CUSTOMER NOTIFICATION

SUD-T-5143-1-E
February 6, 2001
Yoichi Hirasawa, Expert Microcomputer Engineering Dept. Solution Engineering Div. NEC Electron Devices NEC Corporation

**IE-789882-NS-EM1  
(Control Code: B)  
Operating Precautions**

Figure 2-1. Position of Emulation Board Fixing Stays (Metal Fittings)

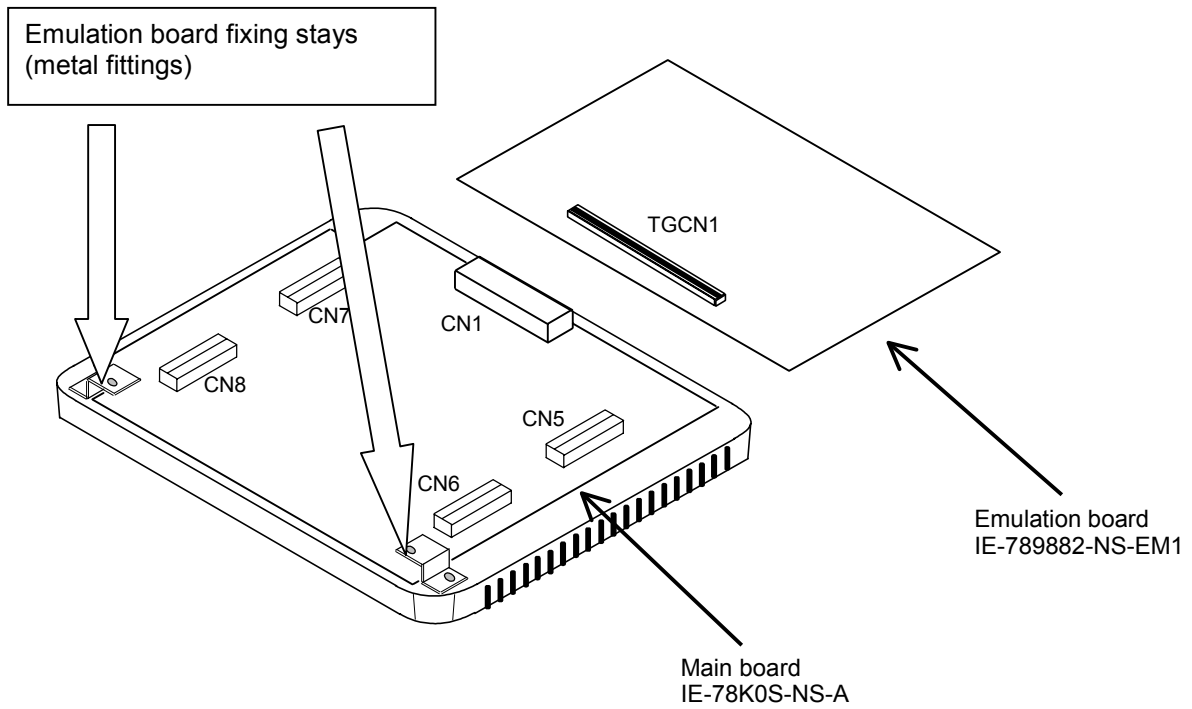
### 2. Contact bug between IE-78K0S-NS-A emulation board fixing stays (metal fittings) and test pin

Description: When connecting the IE-789882-NS-EM1 to the IE-78K0S-NS-A control code A or B, a test pin of the I/O board (CP5) contacts the IE-78K0S-NS-A emulation board fixing stays (metal fittings).

Workaround: This bug has been corrected with the IE-789882-NS-EM1 control code B.

Customers who have not yet upgraded to the IE-78K0S-NS-A control code C should retain the IE-78K0-NS-A emulation board fixing stays (metal fittings) removed as the control code A temporary workaround for modification when upgrading the IE-78K0-NS-A.
